<b>Wulfsberg Electronics</b> <i>A Chelton Group Company</i>		<b>TITLE:</b> <b>SERVICE BULLETIN WSB IDU-III-21</b> <b>(SOFTWARE APPLICATION VERSION 6.0B)</b>	
<b>APPROVALS</b> DRAWN R. DuRall CHECKED Dean Boston PRODUCT MANAGER ---- ENGINEER R. DuRall ISSUED Leslie Evans	<b>DATE</b> 12/20/07 01/03/08 --- 01/03/08 01/04/08	<b>SIZE</b> <b>A</b>	<b>CAGE CODE</b> <b>1B7G3</b>
<b>Typed signatures indicate approval. Handwritten signature approval of this document is on file at Wulfsberg Electronics, Prescott, Arizona.</b>		<b>DWG NO.</b> <b>150-045082</b>	<b>REV</b> <b>E</b>
		<b>SCALE:</b> NONE	<b>DO NOT SCALE DRAWING</b>

## SERVICE BULLETIN

**BULLETIN NUMBER:** WSB IDU-III-21 Revision E

This modification updates the application software to 6.0B.

**Figure 5 Speed Settings Page**

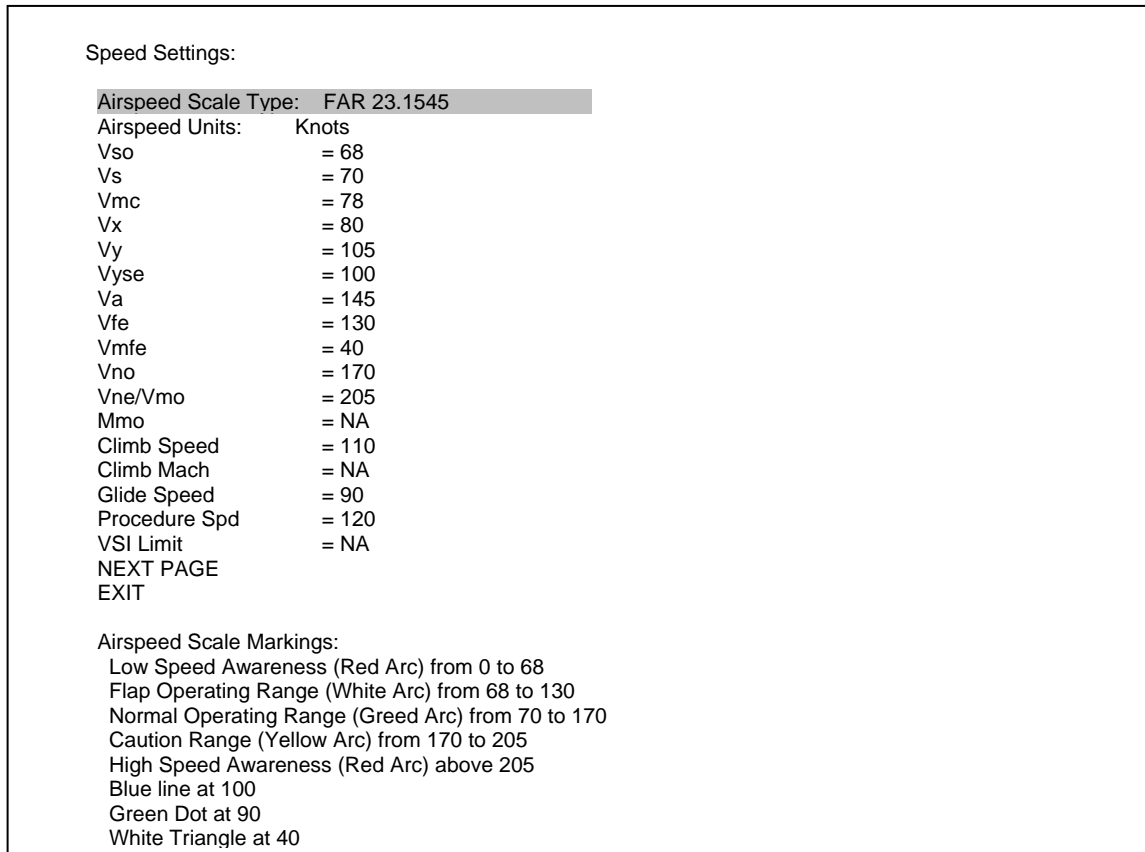
**NOTE:** The following changes to the Speed Settings page are:

Vyse changes to Vnepo when FAR 27.1545 or FAR 29.1545 are selected.

Vmfe changes to “Wht Triangle” when FAR 27.1545 or FAR 29.1545 are selected.

VSI Limit is added when FAR 27.1545 or FAR 29.1545 are selected.

“Blue line” is replaced with “Red/White Hashed Line” when FAR 27.1545 or FAR 29.1545 are selected and is set by Vyse or Vnepo.

**CAUTION:** VSI Limit for all B407 installations under STC SR02203AK must be set to “+2000”.

**Figure 6 System Factory Programmed Settings Page**

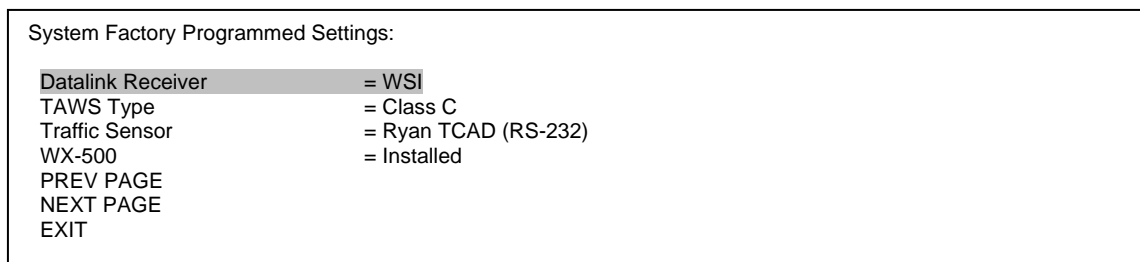
**NOTE:** The following change has been made to the System Factory Programmed Settings page.

Datalink Receiver – selected as “Disabled” or “WSI”. This setting is programmed at the factory and cannot be modified in the field.

TAWS Type – will be selected as “Fixed Wing” for FAR 23 or FAR 25 or “Helicopter” for FAR 27 or FAR29 aircraft.
